SUBJECT:NEW VEHICLE DEMONSTRATION / DELIVERY HOLD
Safety Recall 23S49 - SUPPLEMENT #2
Certain 2023 Model Year F250-F350 with 10.5" Axle Shaft
Left Axle Shaft Failure at FlangeREF:NEW VEHICLE DEMONSTRATION / DELIVERY HOLD
Safety Recall 23S49 - SUPPLEMENT #1
Certain 2023 Model Year F250-F350 with 10.5" Axle Shaft
Left Axle Shaft Failure at Flange

CERTAIN 2023 MODEL YEAR SUPERDUTY VEHICLES EQUIPPED WITH A SINGLE REAR WHEEL (SRW) 10.5 AXLE — LEFT AXLE SHAFT FLANGE INSPECTION

FIGURE 1

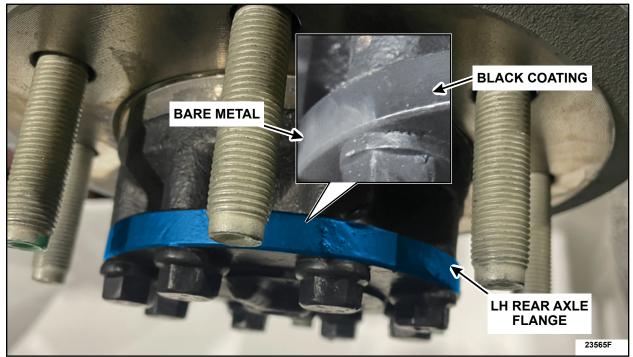
2. Using a right angle grinder with a wire wheel, apply light pressure and remove the black coating on the LH rear axle flange to expose the bare metal. See Figure 1.

FIGURE 2

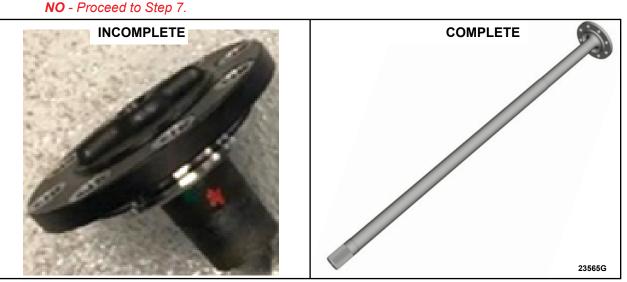
CPR © 2023 FORD MOTOR COMPANY DEARBORN, MICHIGAN 48121 10/2023 3. Locate the pin stamp on the LH rear axle flange. See Figure 2. Was the pin stamp missing?

- **YES** Take pictures of the axle flange and send them to SSSC. The axle **DOES NOT PASS** inspection; *Proceed to Step 5*.
- **NO** Proceed to Step 4.
- 4. Was the first digit on the pin stamp a 1 or 2? See Figure 2.
 - **YES** Take pictures of the axle flange and send them to SSSC. The axle **DOES NOT PASS** inspection; *Proceed to Step 5*.
 - NO The axle <u>PASSED</u> inspection. Install the LH rear wheel. Follow the WSM procedures in Section 204-04A. This completes the FSA.
